# W. Rosemary St. Hotel - Revisions from CDC Concept Options

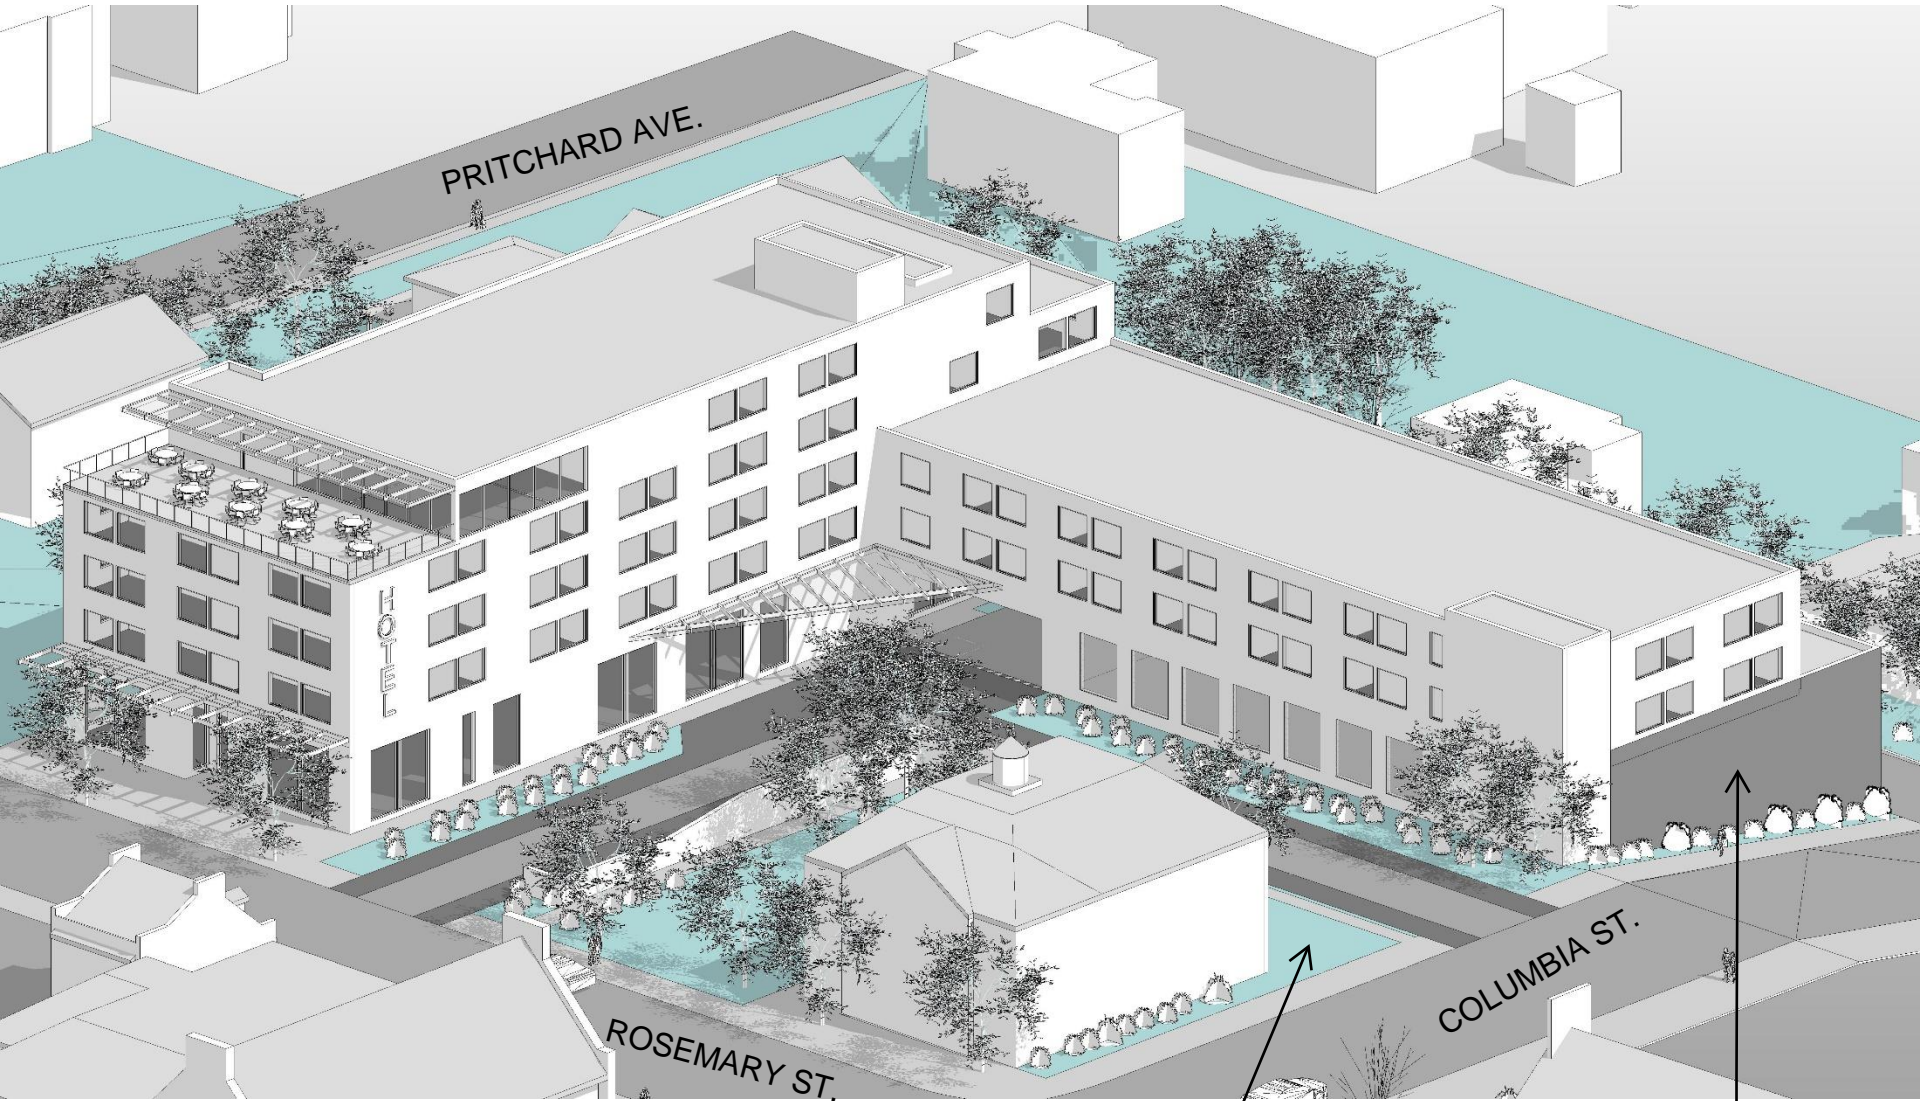
- Height
  - Was 7/4 stories; now 5/4/3 stories
  - Revised option is within solar overlay except for single story penetration on Rosemary wing
- Massing - West Rosemary Guide
  - Maintain 20' building setback at Rosemary St.
  - Step down to 4 stories at north adjacent to residential
  - Step down at Columbia entry view
  - Ground floor use encourages pedestrian activity
- Concealed parking and service functions
  - Structured parking / valet solution
  - Refuse under roof
- Place-making improvements around Historic Town Hall
  - 2 parking /park options for consideration
    - Option 1: Provide more Town parking
    - Option 2: Provide more pocket park
